Work Order ID 99923

Item Name: Basket Hoop

DRAWING NO. D3166	TITLE BASKET.HOOP	REV.A1	DART AEROSPACE LTD ENGINEERING ORDER		D.E.C. NO D3166-A-2	SHEET NO. 1 OF 1	SCALE NTS
DRAWN AJS	CHECKED 1	MFG. APPR. M	APPROVED MD		DE APPR. H		
DATE 08.12.11	DATE 08.12.15	DATE 08/12/15	DATE 08/12/16		DATE 08.12.16

D3166-1 BASKET HOOP

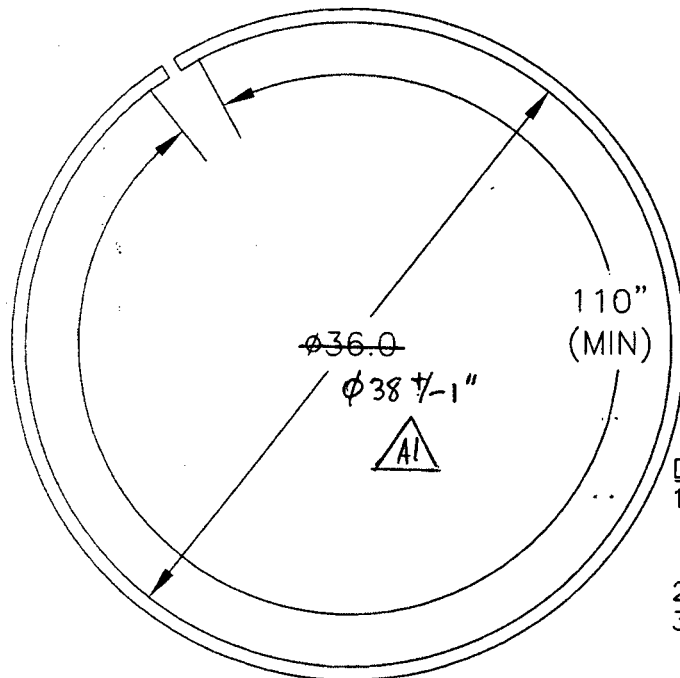
1) MODIFY MATERIAL NOTE FOR D3166-1 AS SHOWN:

WAS:

1) MATERIAL: AISI 304/316 SS SQUARE TUBING,  
0.75" x 0.75" x 0.063 WALL, 60.00" LONG  
(REF DART SPEC. M304TS0.750W.063)

2) MODIFY MATERIAL NOTE FOR D3166-3 AS SHOWN:

WAS:

1) MATERIAL: AISI 304/316 SS SQUARE TUBING,  
0.75" x 0.75" x 0.063 WALL, 120.00" LONG  
(REF DART SPEC. M304TS0.750W.063)

IS:

1) MATERIAL: AISI 304/316 SS, 3/4 X 3/4 X 0.065 WALL SQUARE TUBING,  
60.00" LONG  
REF. DART SPEC M304TS0.750W.065

IS:

1) MATERIAL: AISI 304/316 SS, 3/4 X 3/4 X 0.065 WALL SQUARE TUBING,  
120.00" LONG  
REF. DART SPEC M304TS0.750W.065
